PLAN COMMISSION MEETING AGENDA

MONDAY, AUGUST 10, 2026 AT 4:30 PM

A. Review and take action: 600 Commerce Drive (PIN 291-0815-0823-005) – Site Review for a Multi-Tenant Light Industrial Building

BUILDING SAFETY & ZONING DIVISION
PLAN COMMISSION STAFF REPORT

C1 SITE LAYOUT - FULL DIMENSIONS / BLACKTOP AREAS / NO CURB

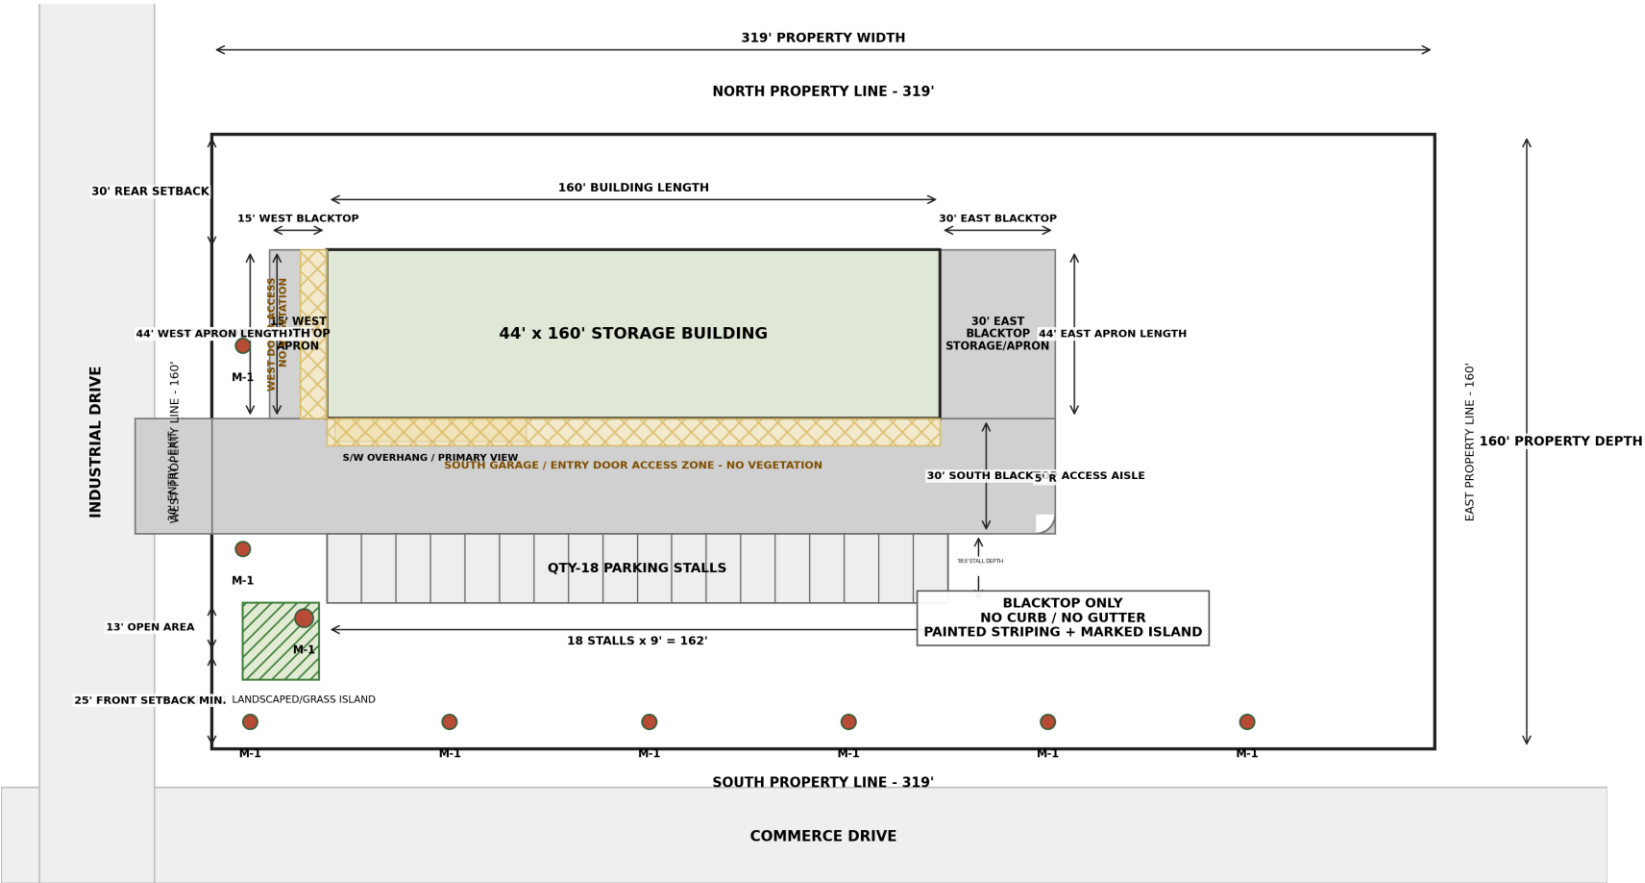
No curbs or gutters are shown or proposed. Blacktop limits now stop at the 30 ft east apron.

E1 LIGHTING PLAN - FIXTURE LOCATIONS AND PHOTOMETRIC SUMMARY

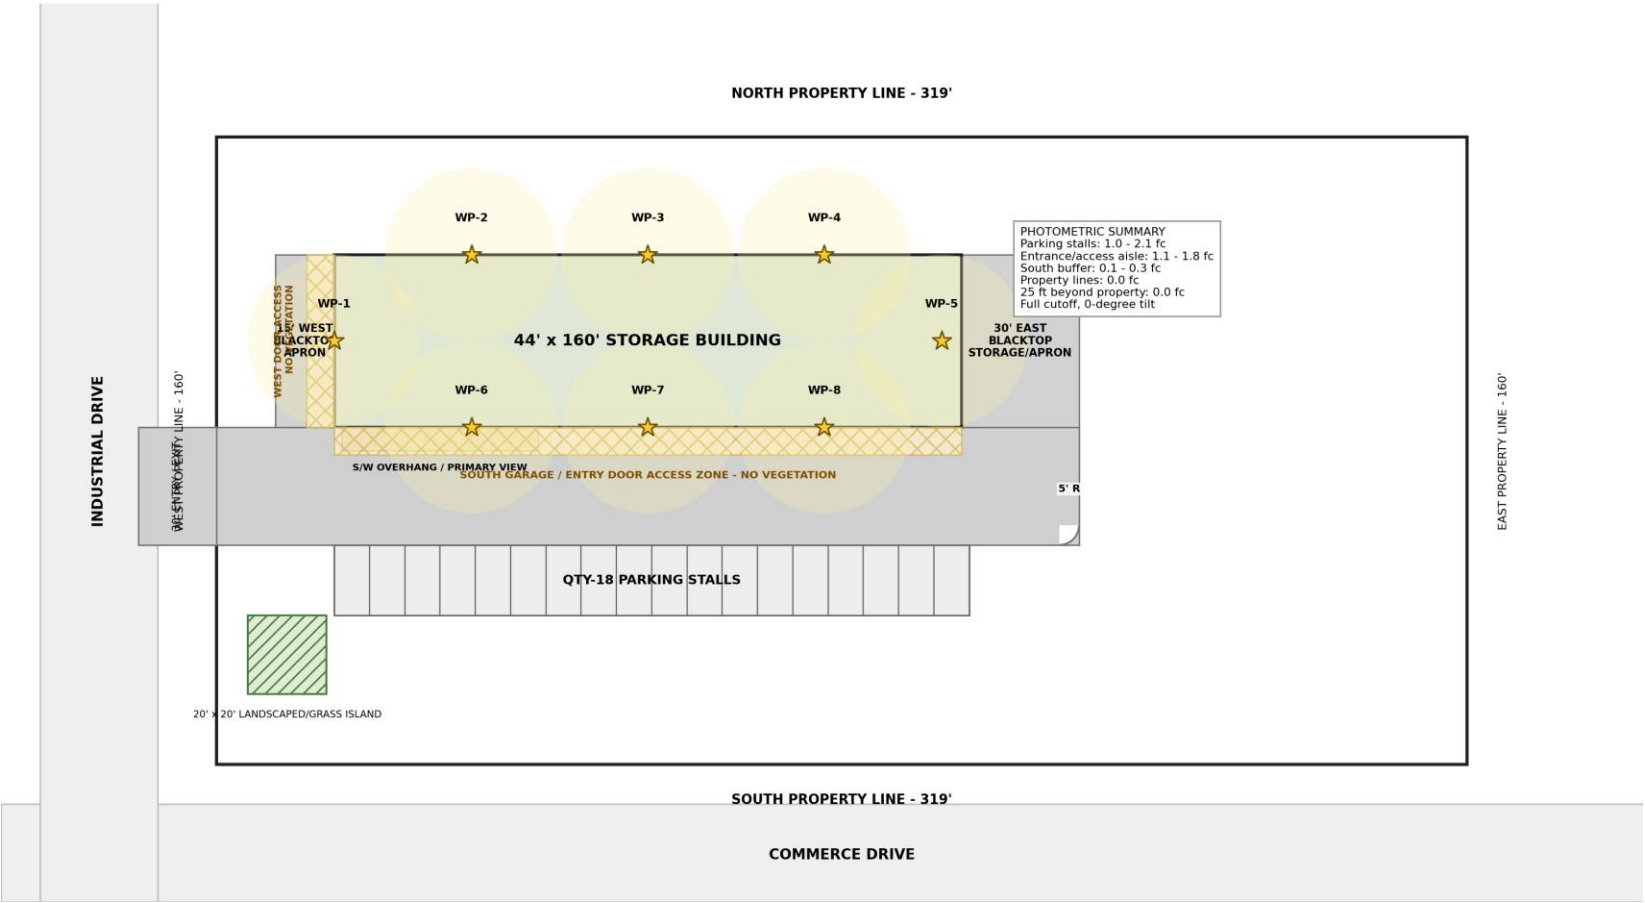
Reference	How addressed
550-107.F(3)	Parking/circulation lighting shown for safe and efficient use
550-110	Shielding, property-line spill and glare control referenced
E1 drawing	Fixture plan and photometric summary shown; WP-5 corrected

E1 LIGHTING PLAN - FIXTURE LOCATIONS AND PHOTOMETRIC SUMMARY

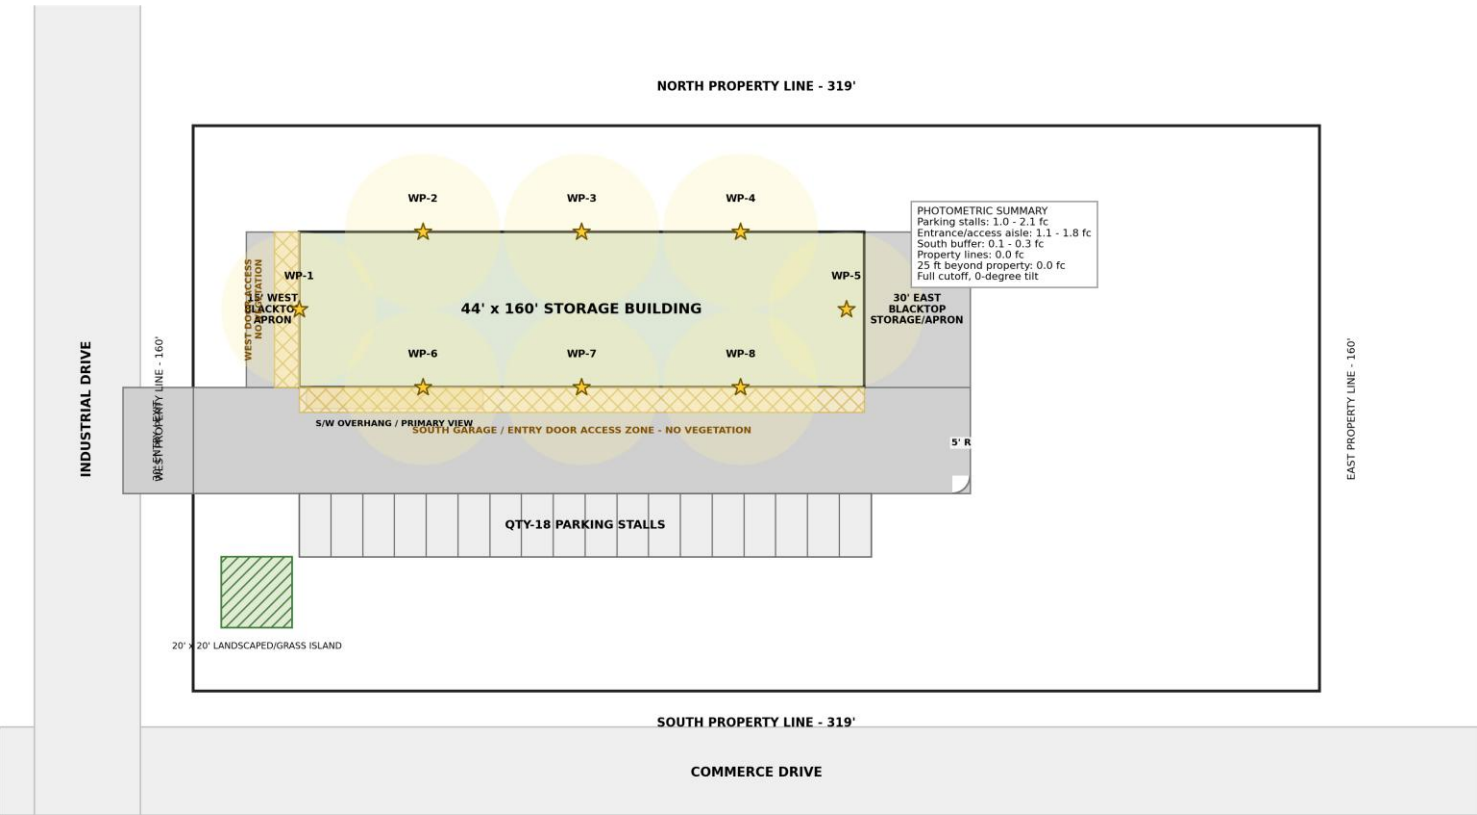
Reference	How Addressed
§550-107.F(3)	Off-street parking and traffic circulation areas serving six or more cars shall be lit for safe and efficient use; provided plan uses wall-mounted fixtures and modeled photometric levels.
§550-110	Exterior lighting standards are referenced for property-line spill, fixture shielding, and glare control.
Project drawing E1	Fixture positions, mounting ranges, and photometric summary are depicted on E1. WP-5 is corrected to the east building wall.

L1 LANDSCAPING PLAN - REQUIRED VS PROPOSED POINT AREAS

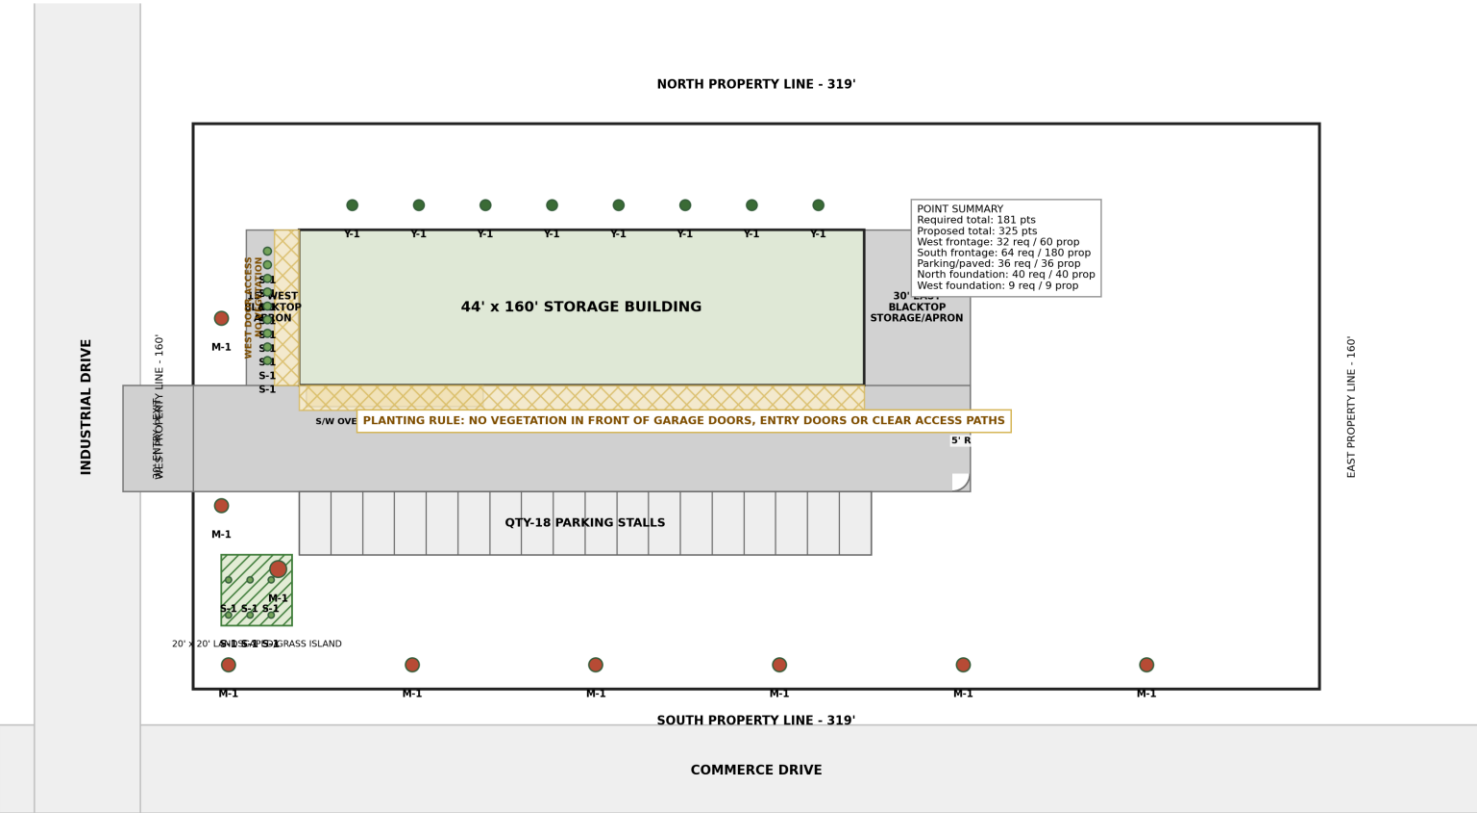
Code Reference	How Addressed
\$550-95	Uses the landscaping point method and plant point values by category.
\$550-96.A	Foundation plantings use shrubs; tall/climax trees are not credited to foundation landscaping.
\$550-96.B	Street frontage plantings are located along the public street frontage, within the property, and arranged to avoid visibility hazards.
\$550-96.C	Paved-area landscaping includes a 20 ft x 20 ft landscaped island and plantings within/near the paved area.
\$550-100 / Appendix F	Plant species are selected from or aligned with the listed classification groups: Red Maple, Yew/Taxus, and Spirea.
\$550-101 to \$550-103	Plant installation, maintenance, calculation, and depiction requirements are acknowledged in the submittal notes.

Placement Topic	Final Direction
South property line trees	First south frontage Red Maple starts approximately 10 ft east of the southwest corner, with remaining trees evenly spaced toward the east.
Landscape island tree	Island Red Maple is placed toward the northeast corner of the 20 ft x 20 ft grass/landscape island to avoid crowding the nearby southwest frontage tree and support signage/corner landscaping.
West property line trees	West frontage trees remain inside the property line and outside pavement/door access areas.
Foundation plantings	Dense Yew and Spirea shrubs shall be field located in solid wall segments only and shall not block doors or access paths.

C1 SITE LAYOUT - FULL DIMENSIONS / BLACKTOP AREAS / NO CURB

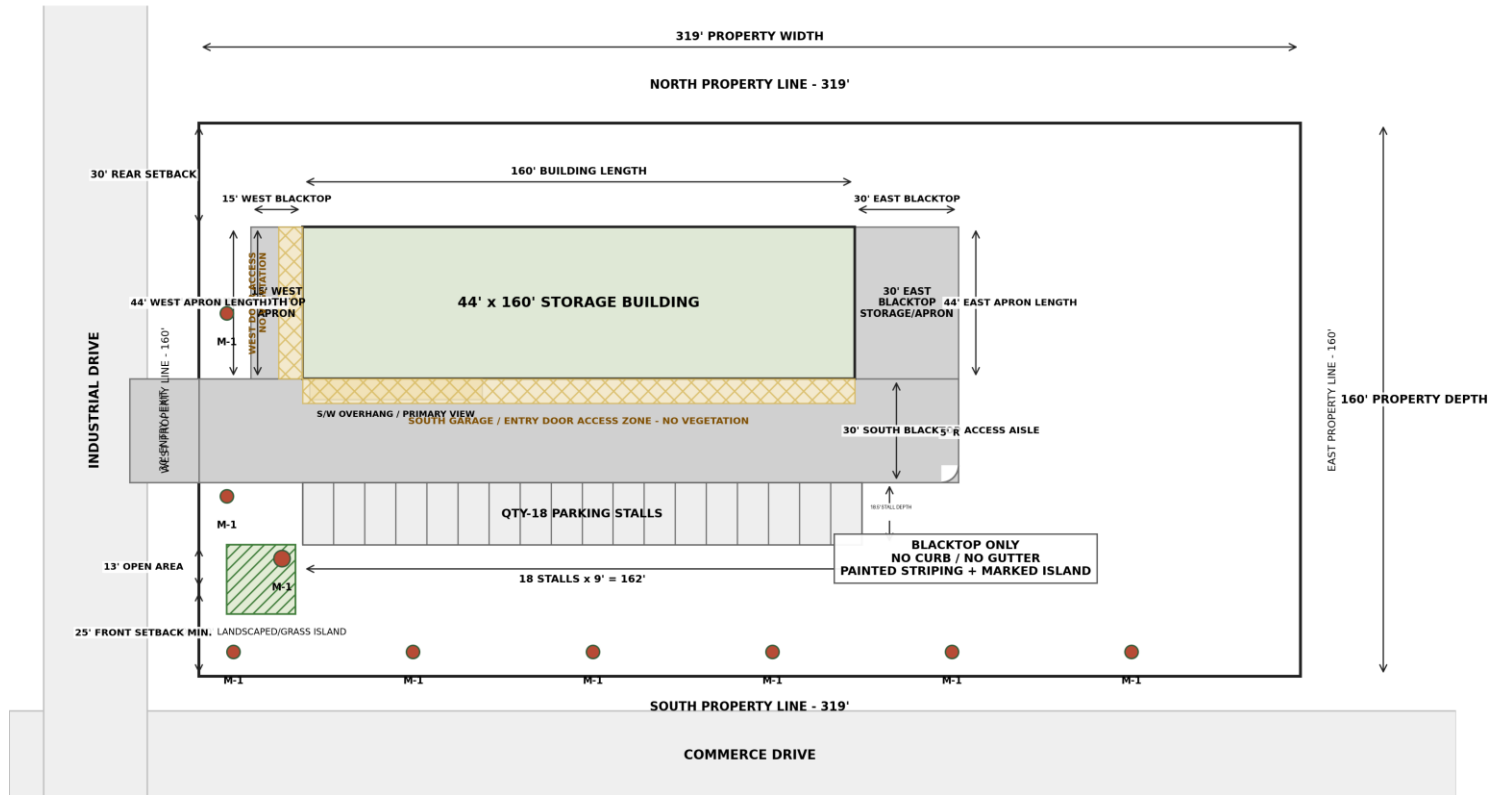
Parking / Traffic Reference	Requirement Summary	Plan Response
§550-107.F(1)	Paved hard all-weather surface and clear markings for lots with six or more spaces.	Proposed blacktop and striped stalls.
§550-107.F(4)	Parking stalls must open onto an aisle/driveway wide enough for safe access.	30 ft aisle provided along south side.
§550-107.F(7) and Table 550-107F(9)	90-degree stall width = 9 ft; stall length and wall-to-wall module standards noted.	Plan shows user-confirmed 9 ft x 18.5 ft stalls; revise to show 18.5 ft effective/overhang if City asks.
§550-107.F(8)	Required parking/circulation areas not used for snow storage.	Note included for operations/maintenance.

CERTIFIED SURVEY MAP No. _____

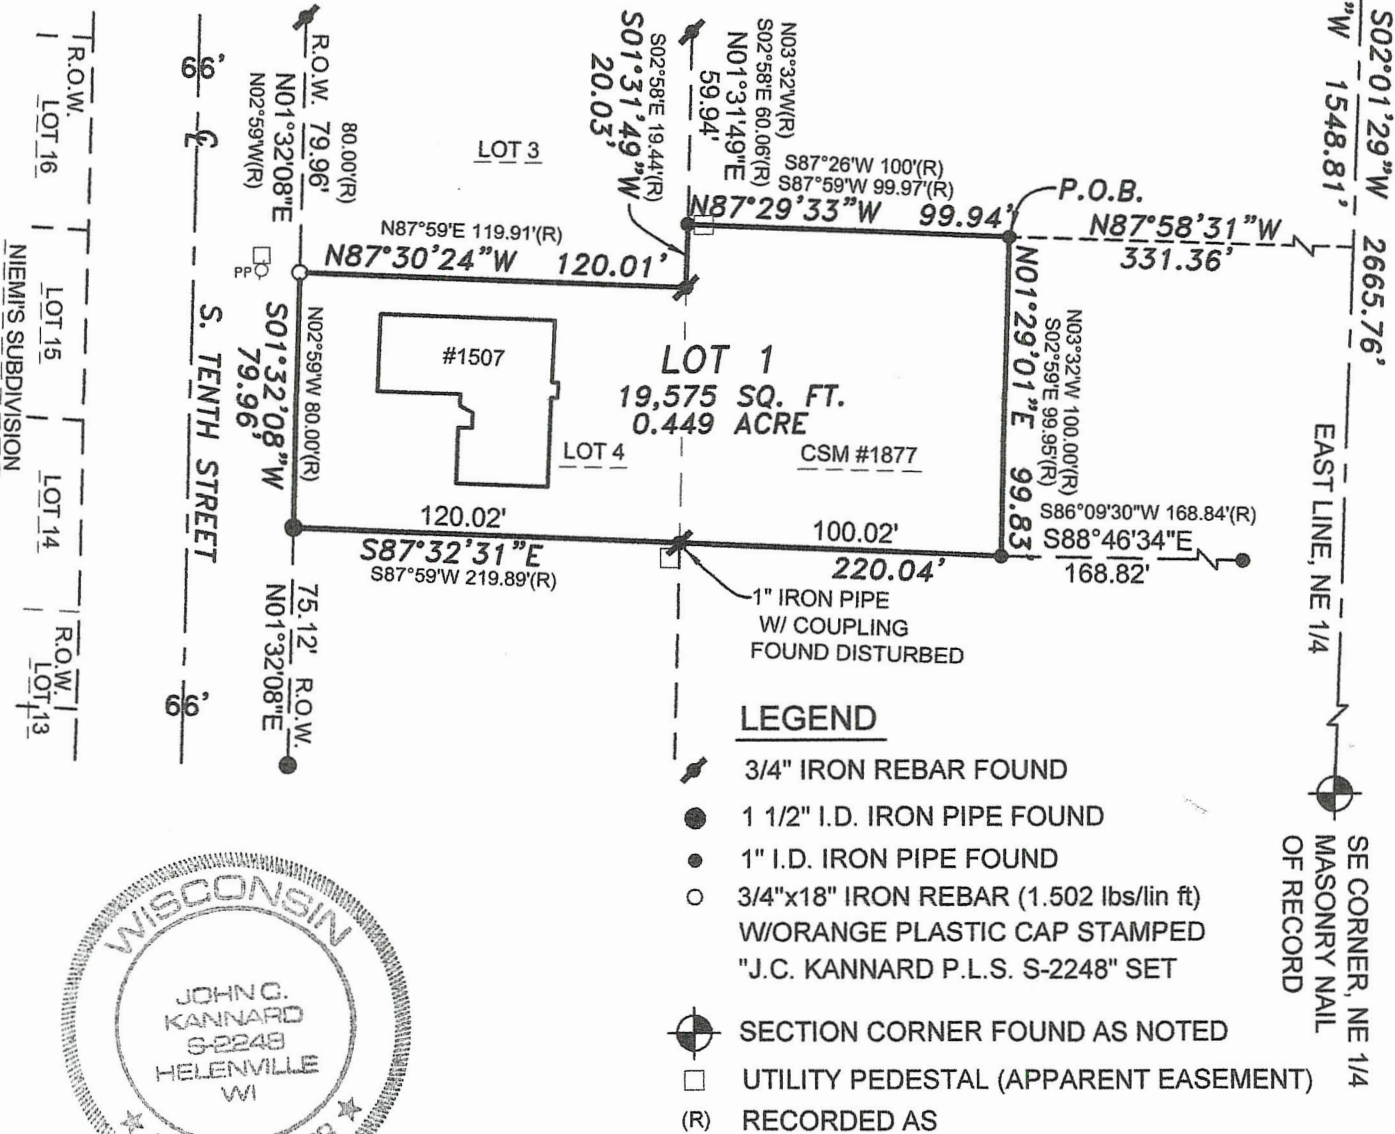
The proposed CSM lot is located within the Airport Approach Protection Zone with a maximum elevation of 900 feet above mean sea level for all buildings and vegetation. A note indicating this elevation has been added to the CSM. The ROW for S 10th Street is adequate in this location. No ROW dedication is required.

NOTE:
Lot 1 has an Airport Protection Zone
elevation limit of 900 feet above sea mean
level for all buildings, structures and
objects of natural growth; whether or not
such buildings, structures and objects of
natural growth are in existence.
